**SB-10058787-8039**Bulletin No.: 15216  
Date: May 2015

# Program Bulletin

## CUSTOMER SATISFACTION PROGRAM

**SUBJECT:** Propshaft U-joint Retainer Bolts Loss of Index**MODELS:** 2015 Cadillac Escalade, Escalade ESV  
2015 Chevrolet Silverado LD Crew and Double Cab  
2015 GMC Sierra LD Crew and Double Cab, Yukon, Yukon XL  
Equipped with 6.2L Engine (RPO L86) and 8-speed Automatic Transmission (RPO M5U)

361391

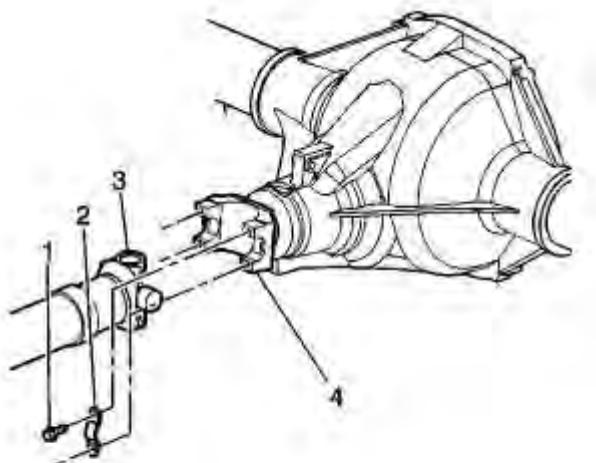
2. Remove the two u-joint retainers (2) and four u-joint retainer bolts (1). Refer to *Propeller Shaft Replacement* in SI.
3. Discard the two u-joint retainers (2) and four u-joint retainer bolts (1).
4. Install two new u-joint retainers (2) and four u-joint retainer bolts (1). Refer to *Propeller Shaft Replacement* in SI. Tighten bolts to **25 Nm (18 lb ft)**.
5. Lower the vehicle. Refer to *Lifting and Jacking the Vehicle* in SI.
